Legalelectric, Inc.

November 21, 2016

RE: **Overland Comment on Pipeline Routing**
OAH Docket: 8-2500-33180
PUC Docket G-011/GP-15-858

ROCHESTER NATURAL GAS PIPELINE
FIGURE 10 (PAGE 7 OF 10)

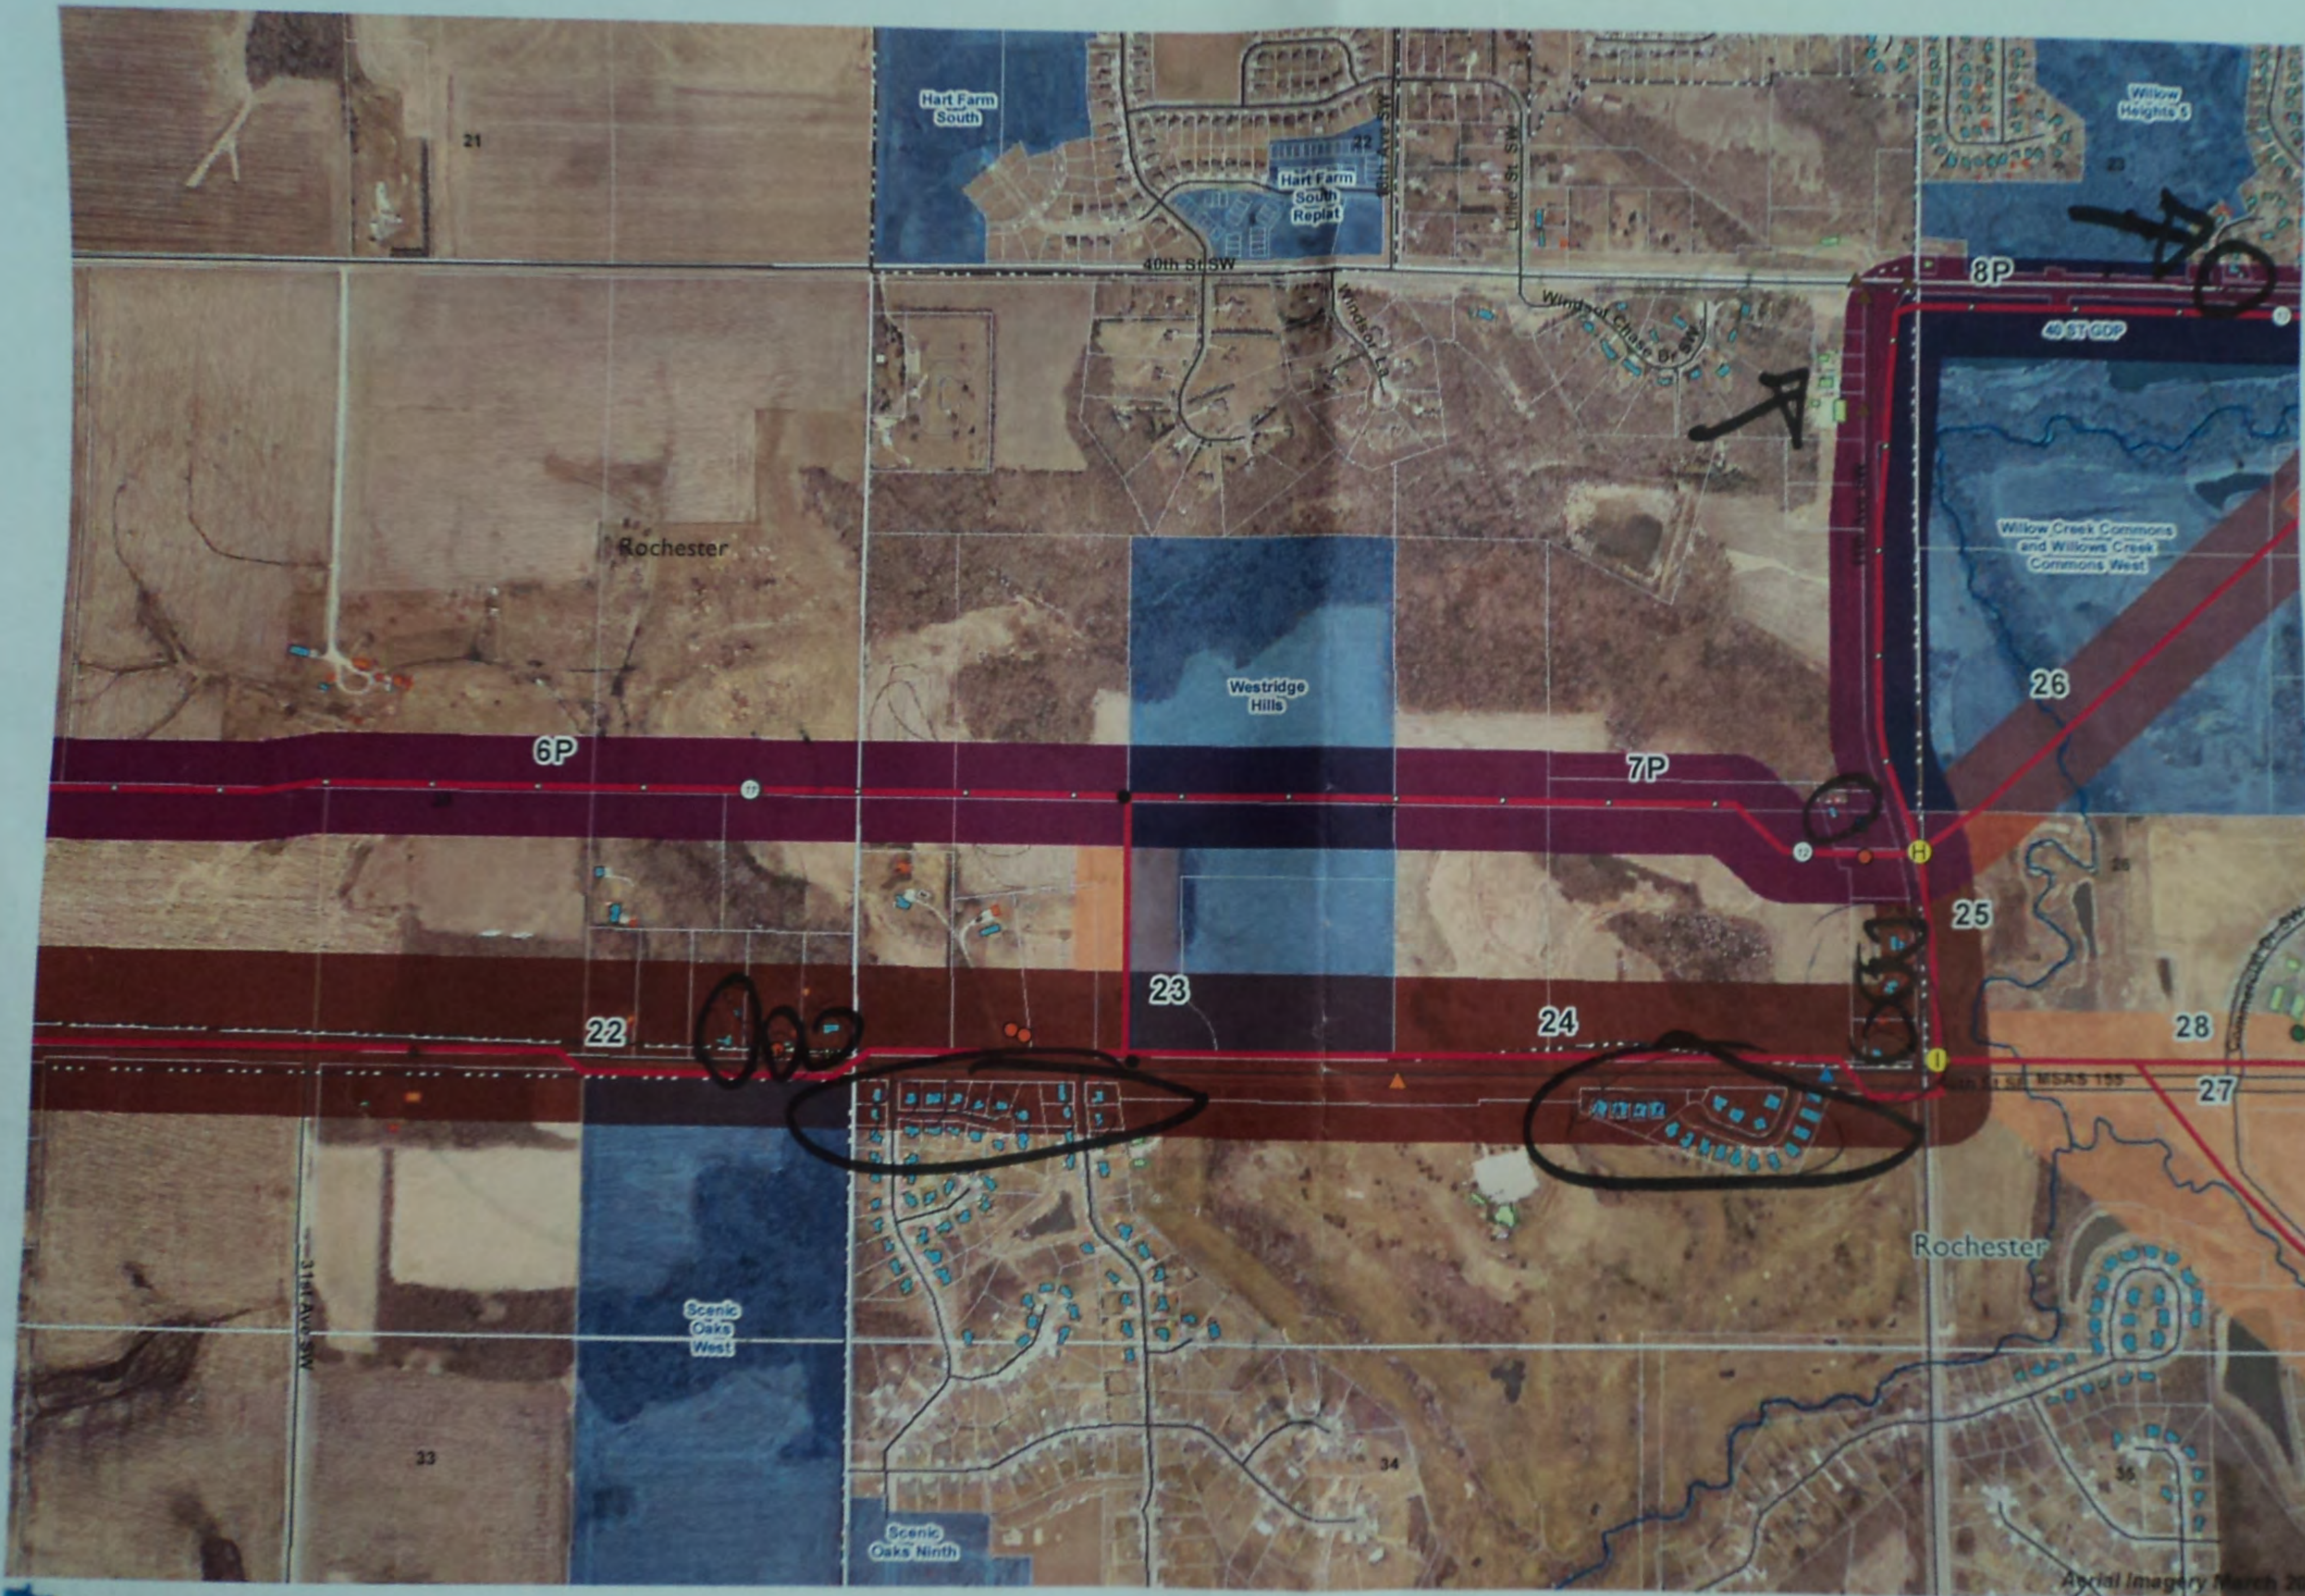
Looking at the maps provided in the Comparative Environmental Analysis, the proximity to homes is unacceptable. Page 1 through the top of page 4 show the 16' 400-475 psig pipeline, and continuing on page 4 through page 10 is the 12" pipeline at 250-275 psig. The maps, with a 500 foot route, within which a 50 foot easement would be set, show the following numbers of homes (see photos of maps, attached, hard copies via mail):

12+ Apple 4 Brown 2 Orange 16+ Brown 105

This project, if granted a route permit, should be routed in recognition of existing and planned land use, sufficiently distant from homes and subdivisions to not interfere with land uses, and to not interfere with landowners use and enjoyment of their property.
